Project	IEEE 802.16 Broadband Wireless Access Working Group < http://ieee802.org/16 >	
Title	Support for 4-Antenna Space-Time Processing	
Date Submitted	2004-03-11	
Source(s)	Wonil Roh, SeungJoo Maeng, Jaeho Jeon, Panyuh Joo Samsung Electronics Corp. 416, Maetan-3dong, Paldal-gu Suwon-si, Gyeonggi-do Korea	Voice: +82-31-794-3868 Wonil.roh@samsung.com ; Sjmaeng@samsung.com ; Jhjeon@samsung.com ; Panyuh@samsung.com
Re:	Contribution supporting Sponsor ballot	
Abstract	Support mechanism for space-time processing with 4 antennas at BS is proposed	
Purpose	Inclusion of the proposed enhancement into the IEEE P802.16-REVd/D3	
Notice	This document has been prepared to assist IEEE 802.16. It is offered as a basis for discussion and is not binding on the contributing individual(s) or organization(s). The material in this document is subject to change in form and content after further study. The contributor(s) reserve(s) the right to add, amend or withdraw material contained herein.

Support for 4 Antenna Space-Time Processing

Figure 1 – Preamble patterns for STP

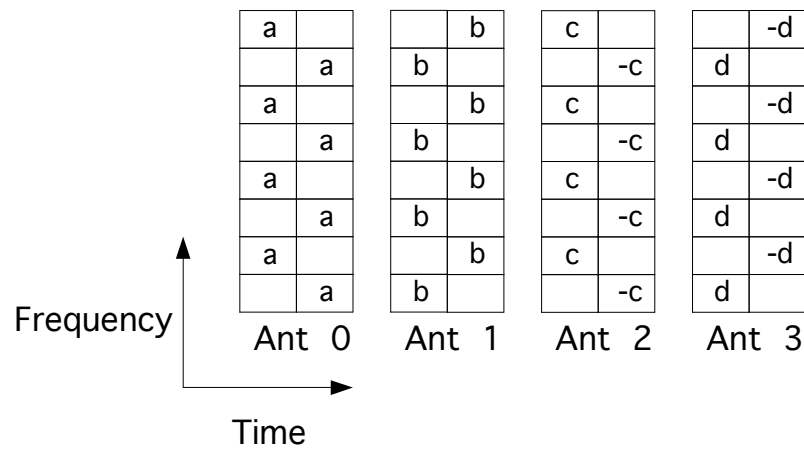
[When STP is employed, orthogonal preamble patterns are transmitted in each antenna over two symbols as shown in Figure 1. In this figure, each block denotes one subcarrier. The underlying idea is to distribute pilots in the preamble in frequency, time and code dimension so that orthogonality between four patterns is preserved. For example, the channel \$a\$ from Antenna 0 and the channel \$c\$ from Antenna 2 are computed at the receiver by simple addition and subtraction, respectively, using two neighboring pilot subcarriers.](#)

[For two-antenna BS, first two preamble patterns \(Ant 0 and Ant 1 in Figure 1\) shall be used.](#)

Figure 2 – Pilot patterns for STP

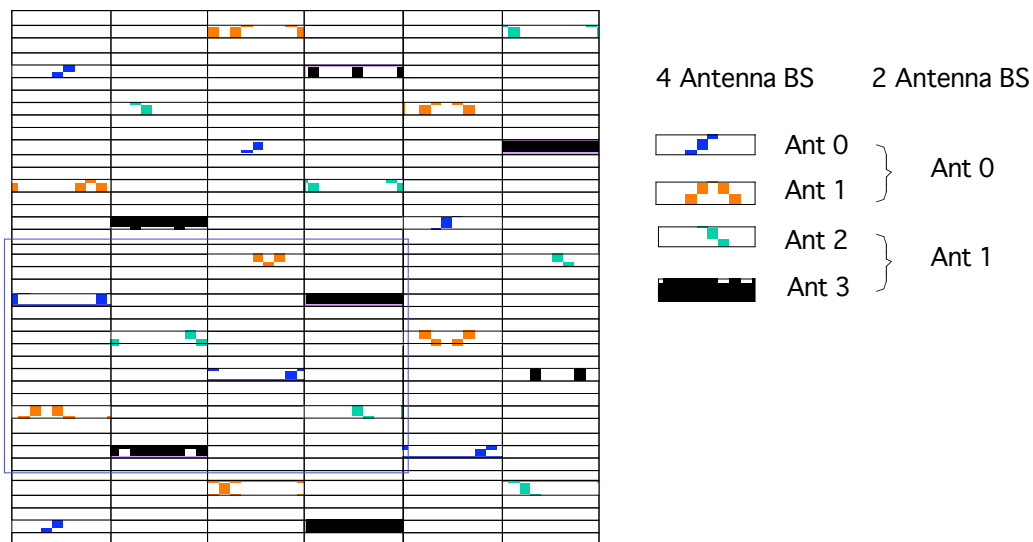
Inside the AMC subchannel, pilot tones for each antenna are well-positioned such that the same structure can be used for UL as well as DL as shown in Figure 2.
